# PHY Control State Machine and Link Monitor

IEEE 802.3bp - Interim Meeting – February 2015

Brett McClellan, Marvell

## Issue 2

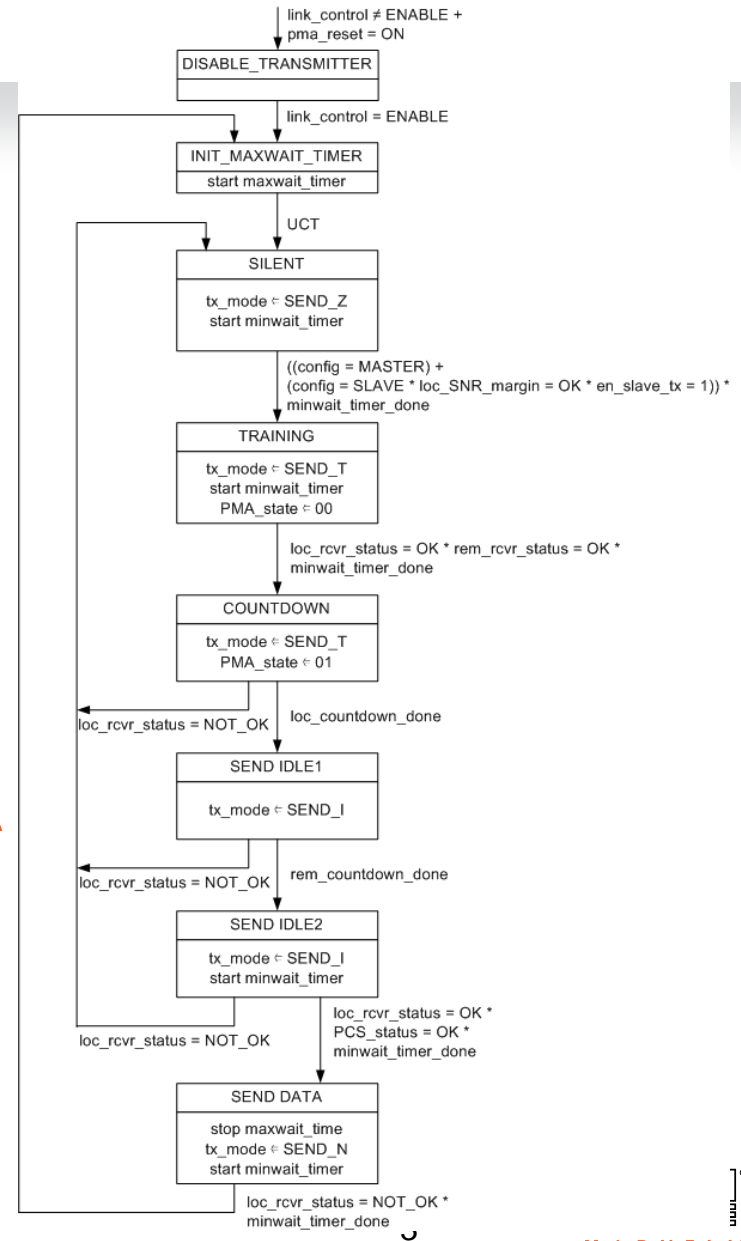
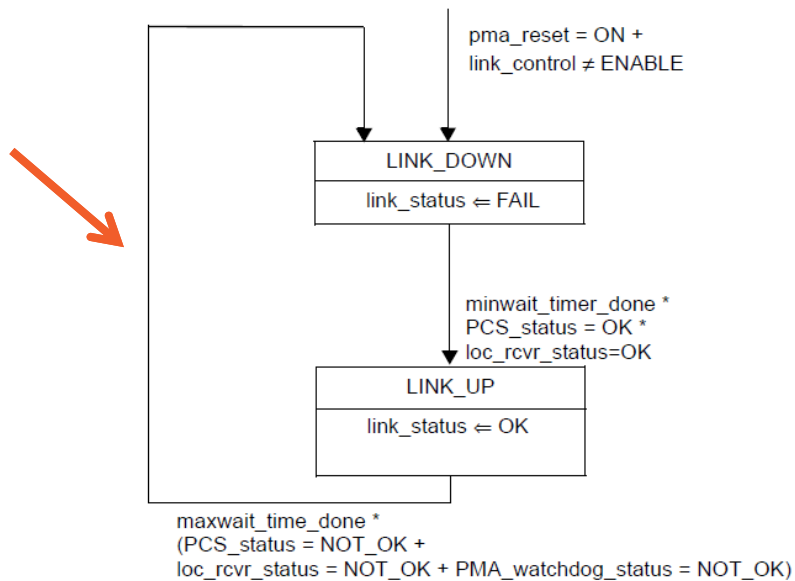
- Quick link down paths in both PHY Control and Link Monitor lead to LD and LP out of sync
- LD: SEND\_DATA -> INIT\_MAXWAIT\_TIMER-> SILENT
- LP: LINK\_UP -> LINK\_DOWN (Autoneg or Synchronization)

## Issue 2: Remedy

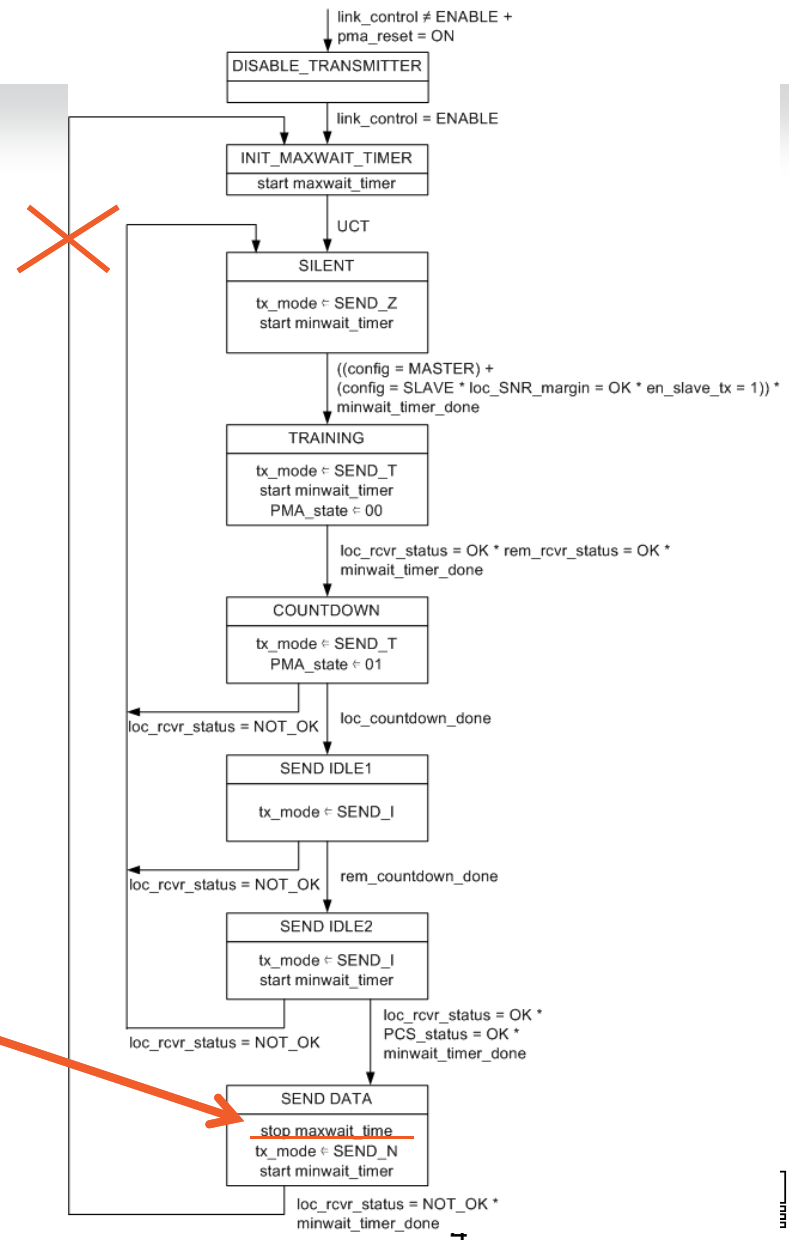
- ~~Remove INIT\_MAXWAIT\_TIMER~~
- ~~DISABLE\_TRANSMITTER~~ → SILENT
  - When link\_control = ENABLE
- In SEND DATA
  - Remove stop\_maxwait\_timer
  - Remove path back to INIT\_MAXWAIT\_TIMER

## Only exit from SEND DATA is through the Link Monitor LINK\_DOWN

- Back to Autoneg or Synchronization
